WORKSHOP AGENDA

Planning Commission

June 13, 2023 @ 5:30 PM

SHEET NUMBER
C2-00

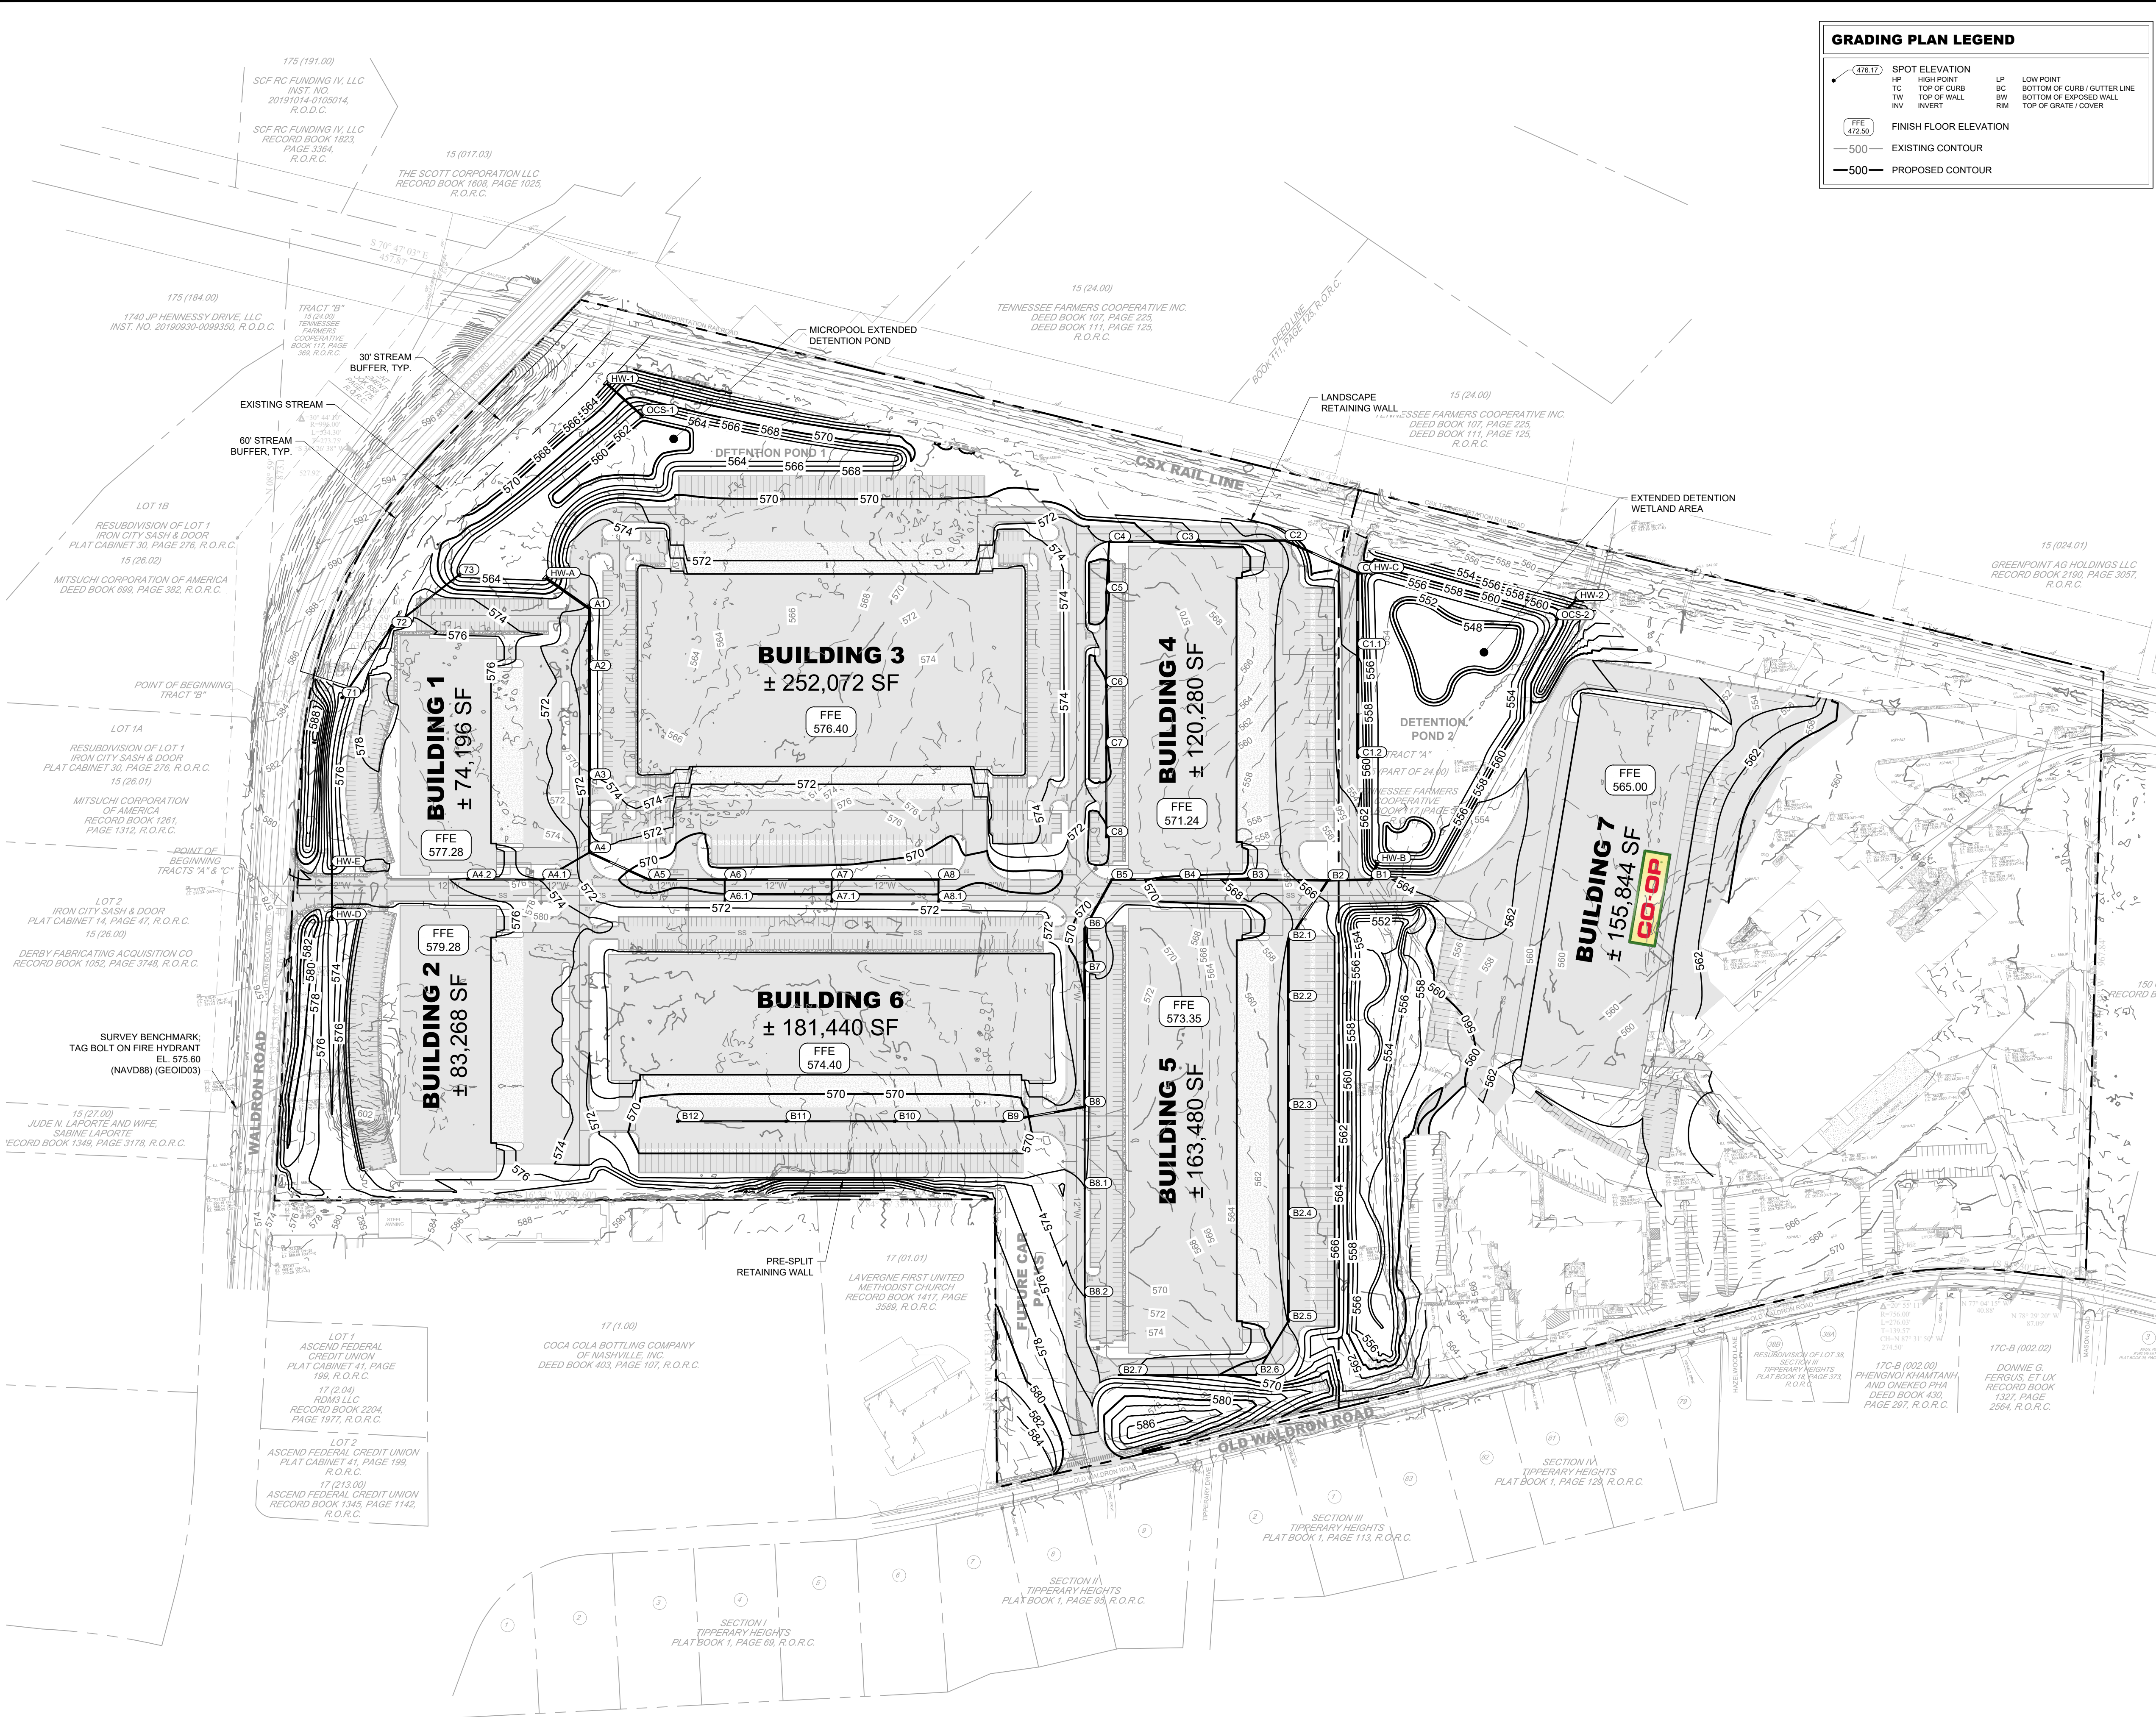
3. In the 'Project Description' on Sheet C0-00, explain what properties are going to be consolidated and subdivided by this plat process.
4. No information is found on the drawings regarding areas prone to flooding. A brief review of the latest FIRM map indicates a small area in the northwest corner of the site that may be backwater flood zones. Clearly indicate areas subject to flooding on the drawings or add a note that the entire site is Zone X.

No.	DATE	BY	REVISIONS									
			1	2	3	4	5	6	7	8	9	10
DESIGNED BY: _____												
DRAWN BY: _____												
CHECKED BY: _____												
DATE: 05/30/2023												
KIMLEY-HORN PROJECT NO. 118163044												
GRADING AND DRAINAGE PLAN - OVERALL												
SHEET NUMBER												
C4-00

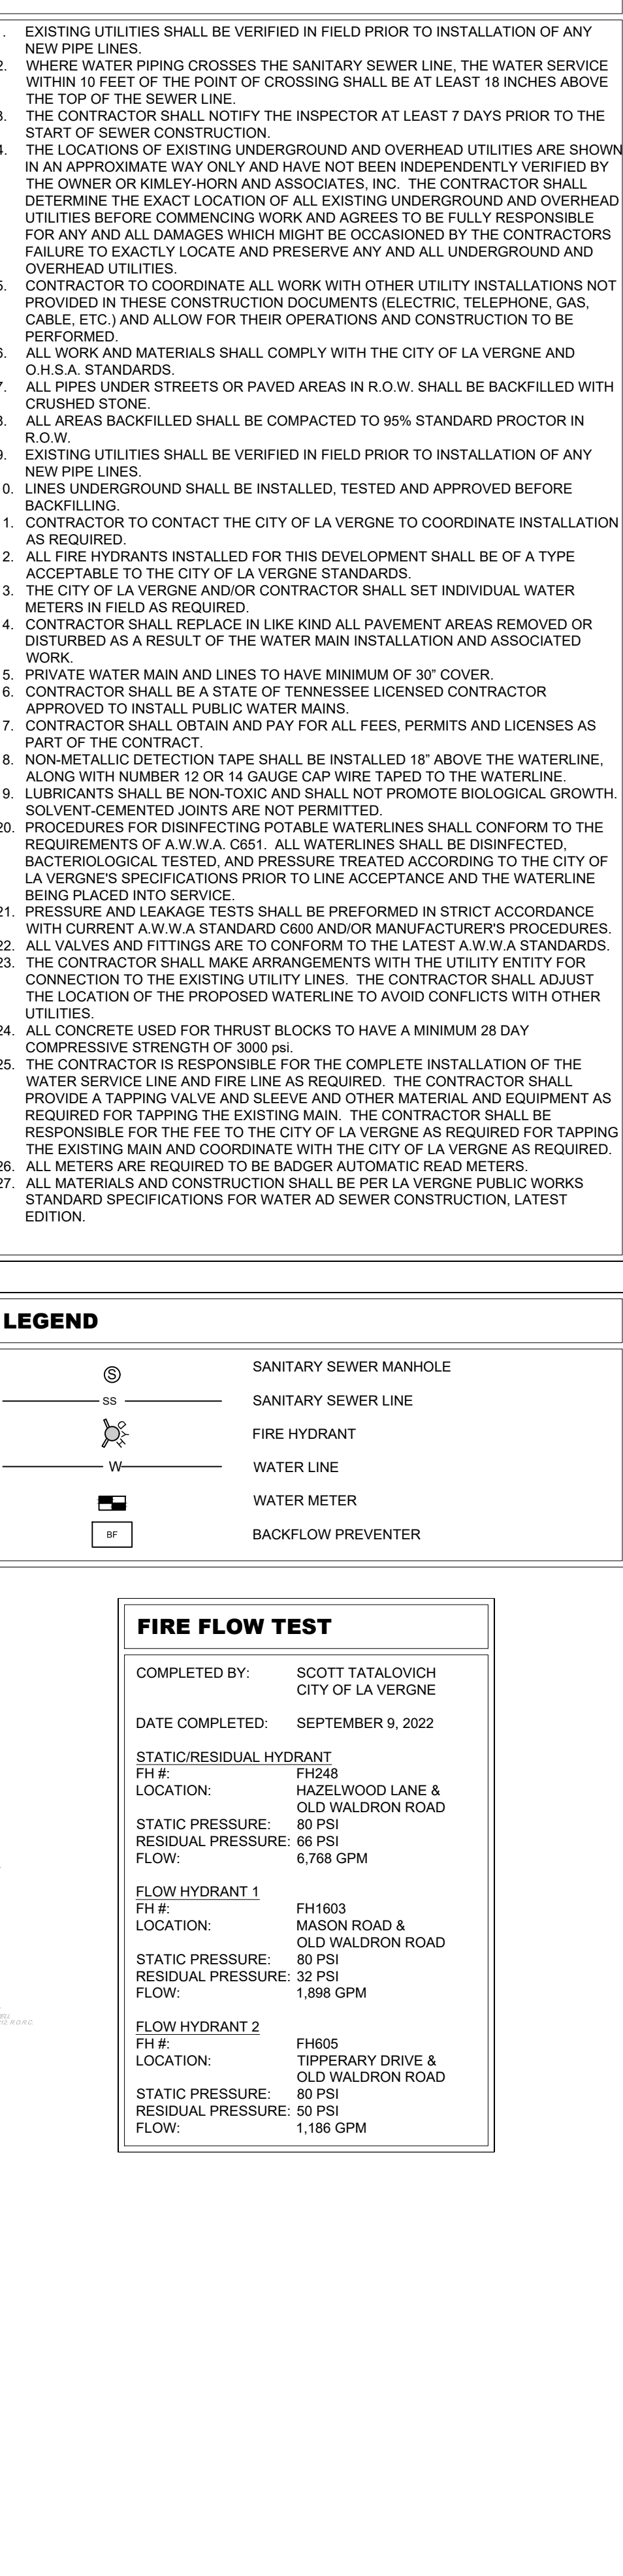
5. Clearly label proposed lot lines.
6. Add a note to Sheet C4-00 locating the area which will contain "constructed wetland-style vegetation" as referenced in the hydraulic study. Be prepared to discuss this before the Commission. The staff considers this a strong positive to the development.

V-1.00

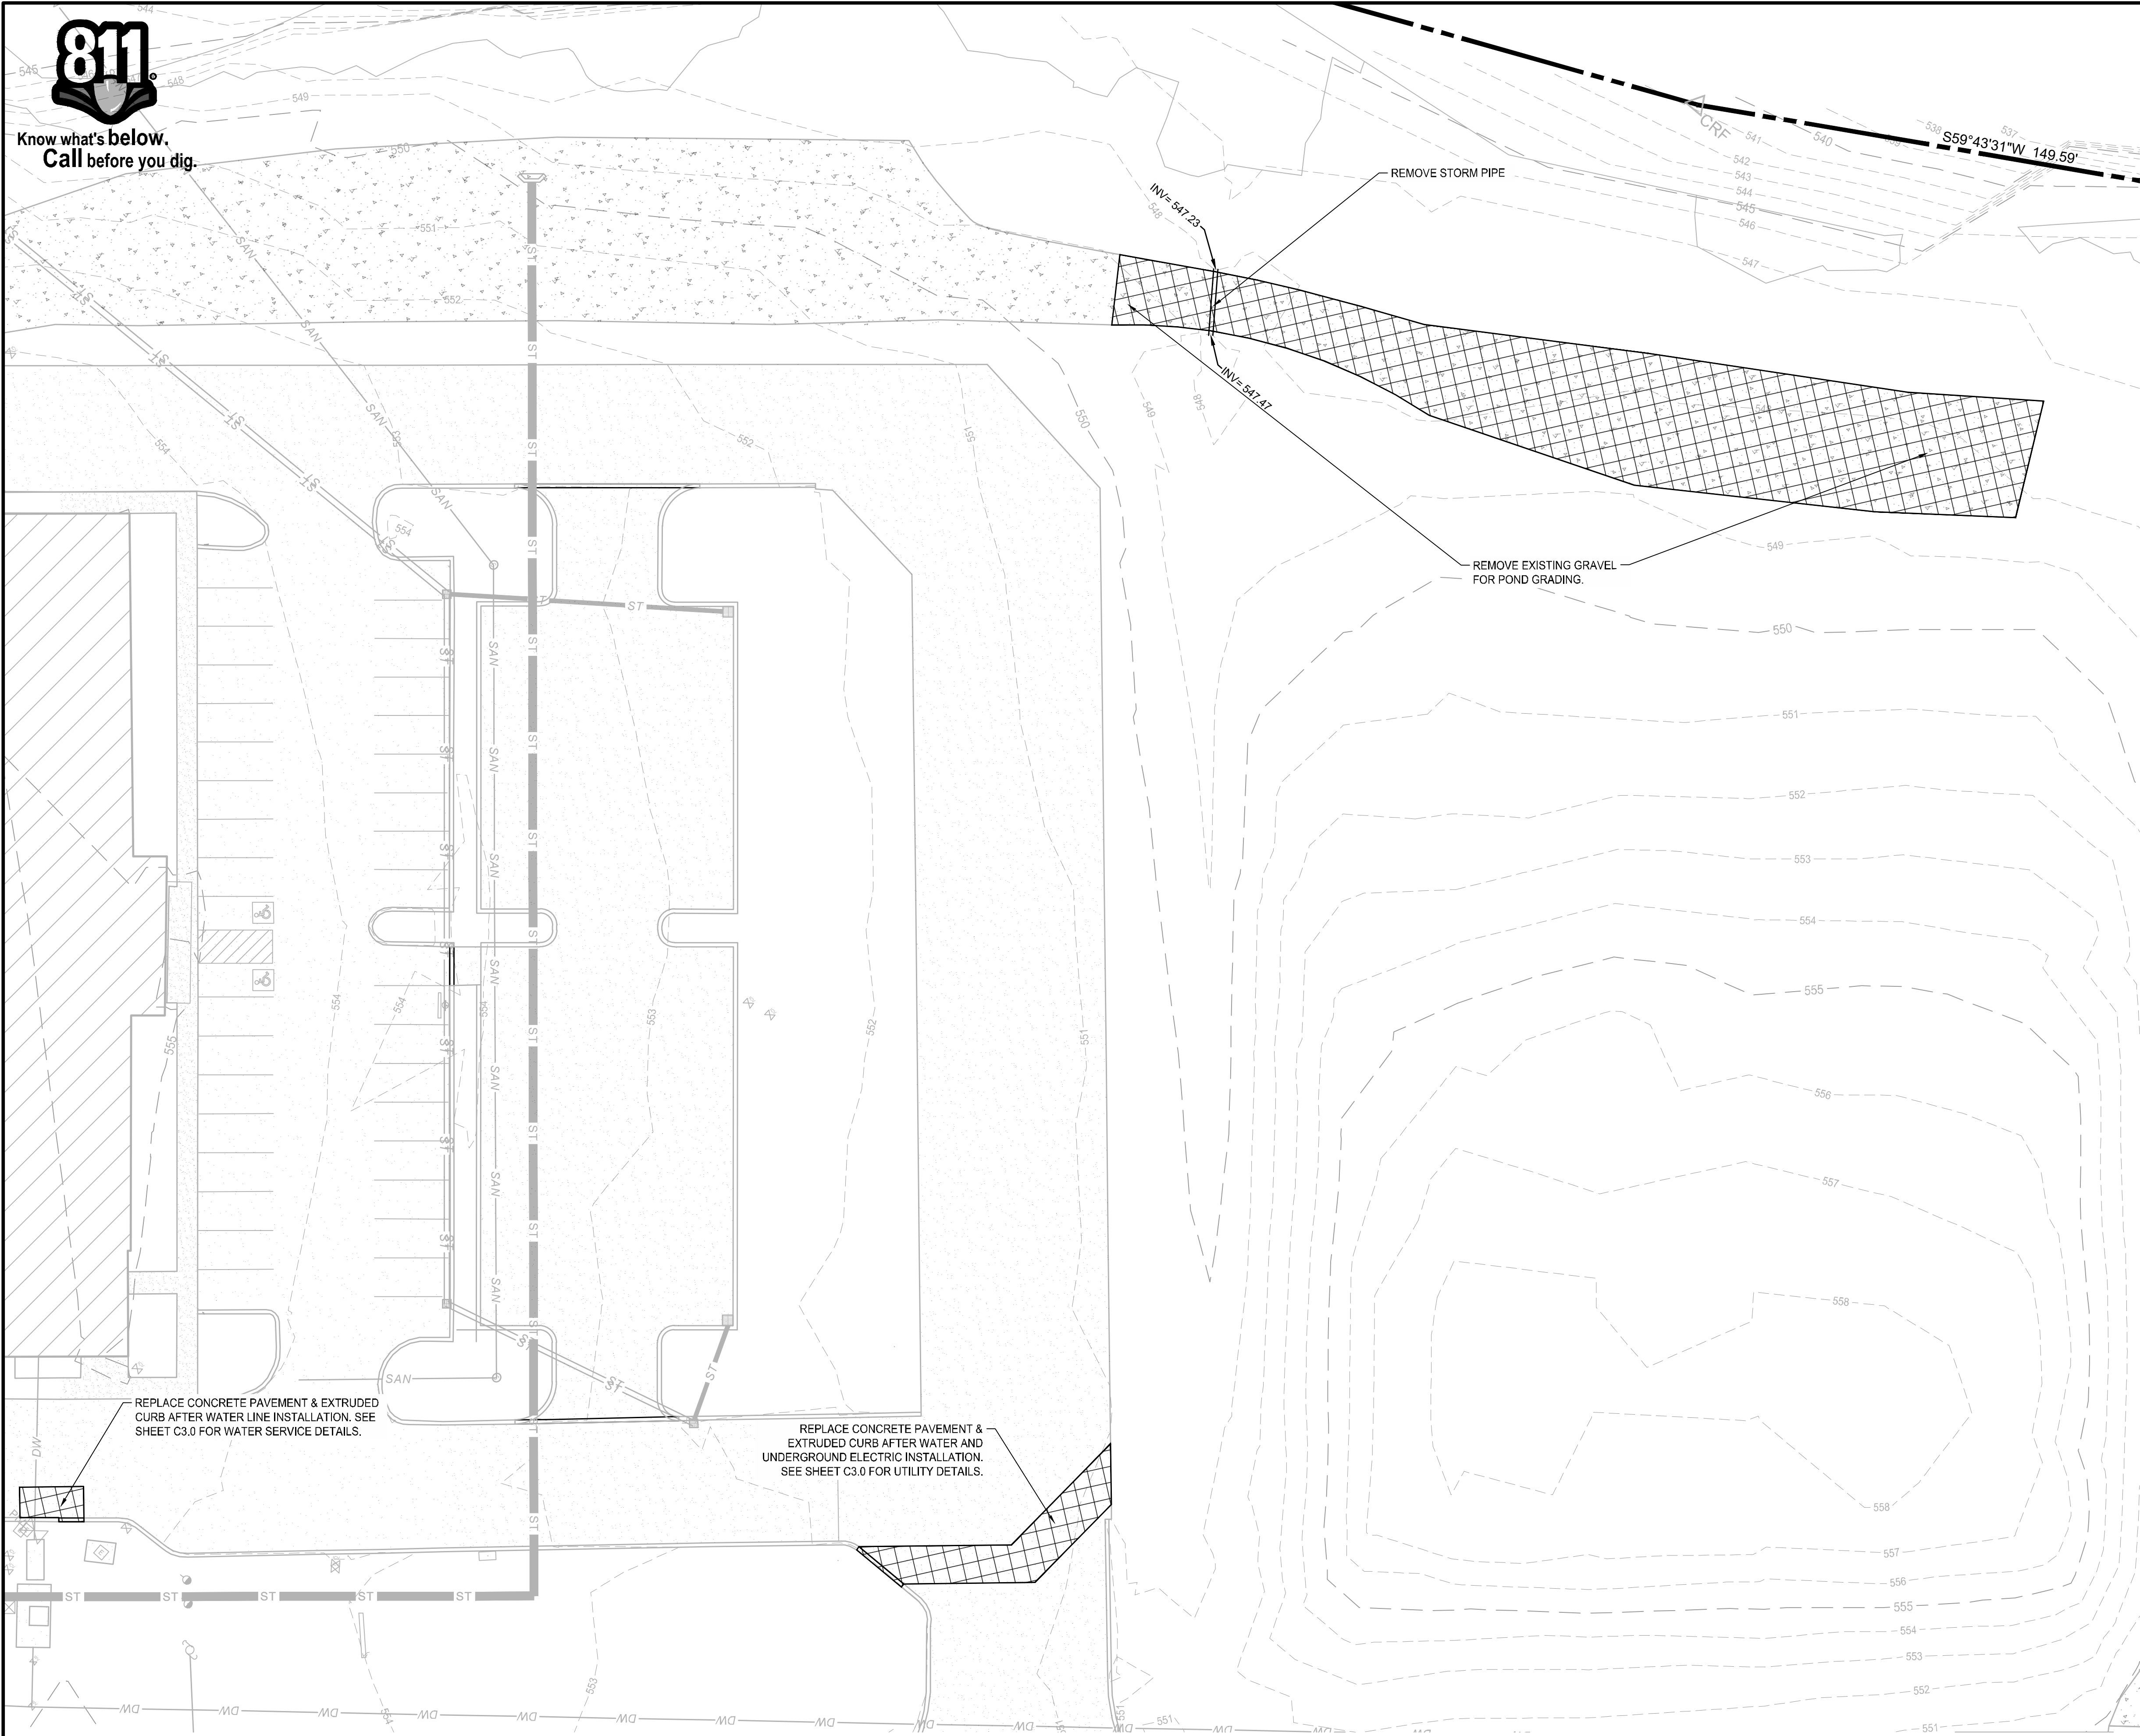
1. (Sheet V-1.00) Show bearings and distances on the overall site property line.
2. (Sheet C1.0) Locate new building from either:
 3. Existing building
 4. Property line
 5. Coordinates
6. (Sheet A-200 and C1.0) No signage is shown on the building and no directional or informational
